## **Determination 2017/009**

# **Regarding compliance with Clause D1 in regards to the use of balustrade capping as a handrail in a house at 29 Chelmsford Avenue, Glendowie, Auckland**

This determination considers whether a balustrade handrail as constructed complies with Clause D1. The determination considers the use of the balustrade capping as a handrail and discusses the relevant width measurement and whether the capping is sufficient to provide a firm grasp in the event of a fall.

Figure 1: The interlinking rail as built

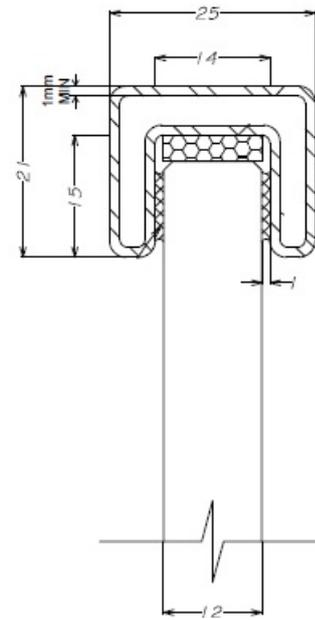
2.3 The handrail as built consists of a 25mm wide x 21mm deep hollow stainless steel interlinking rail bonded to the top edge of the balustrade as shown in Figure 1. The rail runs along the full length of the balustrade.

2.4 I note that while the balustrade capping is called an “interlinking handrail”, that name is derived from NZS 4223.3<sup>4</sup> where interlinking rails are required for frameless glass systems and should not be confused for a compliant handrail. The applicant submitted three “interlinking handrail” designs, and apart from the referenced design in this determination, the other two designs are compliant with D1/AS1.

2.7 The authority emailed the applicant on the same day, setting out its view that the handrail did not comply with the relevant width (RW) dimensions set out in D1/AS1<sup>5</sup> and that the glass balustrade would prevent a person from being able to fully grasp the handrail. The authority noted the applicant could propose an alternative solution, if the applicant believed an adult person could still grip and support themselves during a fall, and submit it as a minor variation. Additionally, the authority noted that the handrail constructed differed from the consented drawings.

- The handrail is not graspable as the glass interferes with the ‘ability to effectively wrap the hand around, and grasp the handrail.’
- The authority’s decision was based on Figure 26(a)(iv) of D1/AS1 as the relevant handrail profile. The width of the capping met the 20mm minimum, but the diagram ‘shows a finite relevant width (“RW”) is not achieved [by] the current set up’ (see paragraph 6.0.8 of D1/AS1 – shown at Appendix A.2). As the capping is mounted on top of the glass, the RW measurement continues down the glass and this exceeds the 80mm maximum for the RW.

- 4.2.7 The proposed handrail submitted by the applicant has a width of 25mm (greater than the 20mm shown in Figure 26(a)(iv)) and the side profile length of 21mm. However, there is no gap between the lower edge of the handrail and glass, and only a 6.5mm indent below the rail. I am of the view that the RW continues down the balustrade, and therefore the handrail exceeds the maximum RW of 80mm set out in paragraph 6.0.8 of D1/AS1.

- 4.3.1 When using the constructed handrail, due to the narrow width and side length, only a small segment of the user's fingers can be in contact with the actual handrail and, unless an awkward grip is used, the majority will be in contact with the glass balustrade underneath. If the glass was not present immediately below the handrail, the user could achieve a firm grip of the handrail.

- 4.3.2 The 6.5mm indent at the below the handrail where it meets the glass requires the user to grip the glass or pinch the handrail when support is required. I note in the commentary of D1/AS1 paragraph 6.0.7 it states that it is important that an adult can 'firmly grasp the *handrail* to prevent a fall.' (emphasis added). A handrail design that allows more of the finger and hand segments into contact with the handrail is likely to permit a stronger grasp than a "pinch grip"<sup>8</sup>. I am of the view that the profile of the handrail as constructed does not provide for a firm grasp, and I consider that it would be inadequate in assisting the arrest of a fall.

- 4.3.3 I conclude therefore that the authority was correct in requiring the handrail design to allow the user to firmly grasp the handrail in the event of a fall, which the handrail profile in conjunction with the glass balustrade does not permit.

- 4.4.1 The proposed handrail does not meet the requirements for a graspable handrail as described in D1/AS1 for relevant width.
- 4.4.2 In my view the proposed handrail does not satisfy the requirements of Clause D1.3.3(j).
- 4.4.3 I suggest that the applicant install a handrail design that complies with the Building Code and submit this as a minor variation to the building consent.

- 5.1 In accordance with section 188 of the Building Act 2004, I hereby determine that the handrail as described in paragraph 2.3 of this determination does not comply with Clause D1.3.3(j) of the Building Code.

Figure 2: Figure 26 of D1/AS1 2<sup>nd</sup> edition, amendment 5

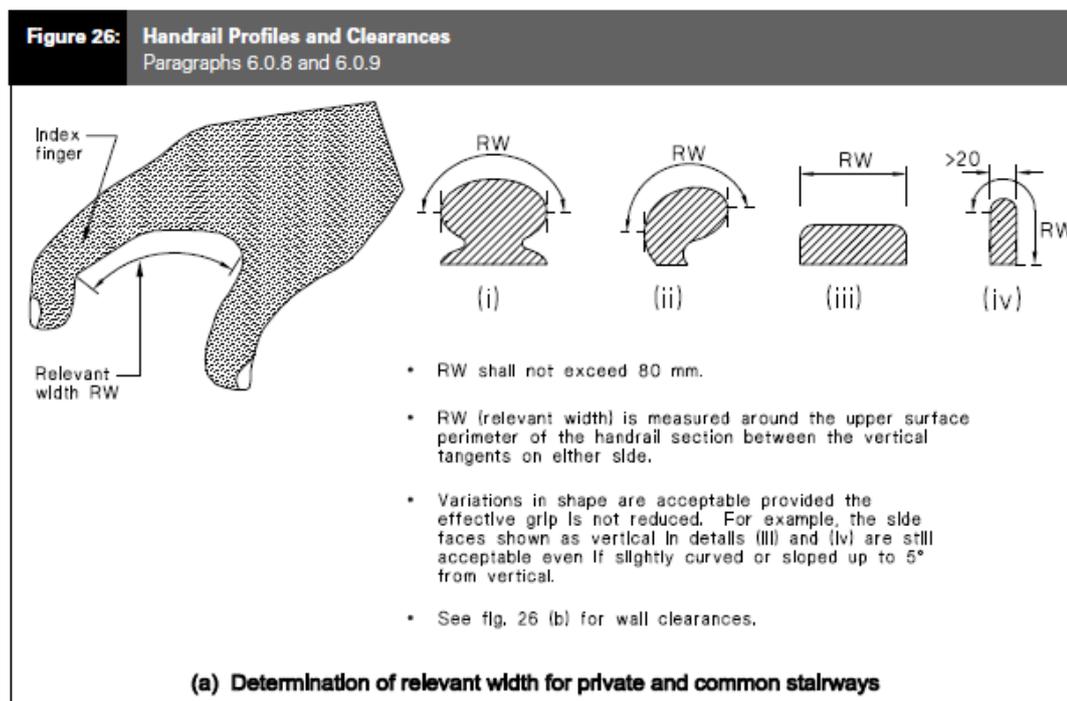
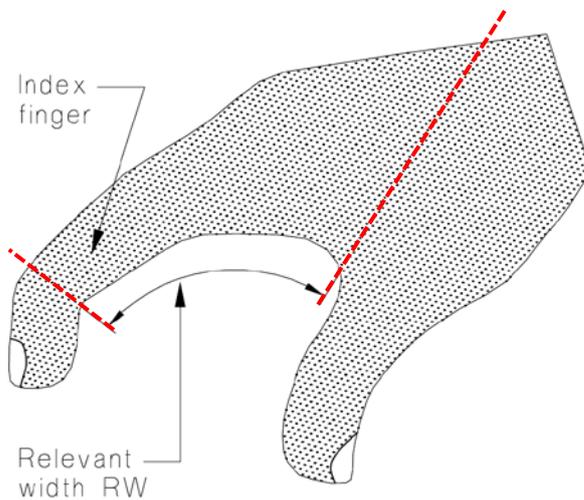
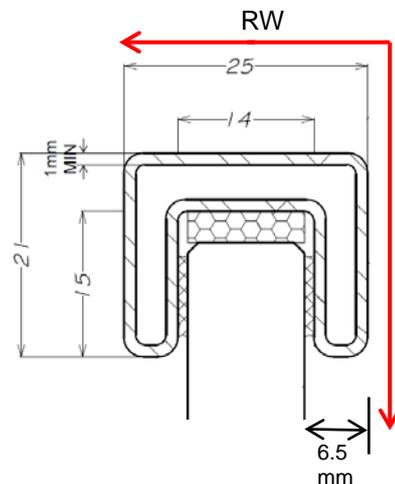
- 4.2.4 The applicant has submitted that compliance is achieved when compared to profile (iii) of Figure 26(a).
- 4.2.5 The authority has identified profile (iv) of Figure 26(a) as the one against which compliance has been assessed. This profile notes the RW as measured along the top surface and down the side of the handrail.

- 4.2.6 I note that D1/AS1 amendment 6 took effect on 1 January 2017, with alterations to profile (iii) in Figure 26(a), with the side dimension included in the RW measurement. I consider it important that the amended diagram shows the RW is taken from the side and top, which is similar to profile (iv). However, as profile (iv) has a similar narrow width, I consider the constructed handrail is closer to (iv) in comparison.

- 4.2.8 Profile (iv) shows that the RW, including the length of the side, must not exceed 80mm to enable the user's fingers to be in sufficient contact with the handrail. I note that it is not explicitly stated in D1/AS1 that the user must be able to grasp the underside of the handrail, but the design is required to permit a firm grasp. I consider this as requiring adequate contact of the hand to the handrail, as demonstrated in the relevant width diagram which highlights the segments of the hand that should be in contact with the handrail (see Figure 3).
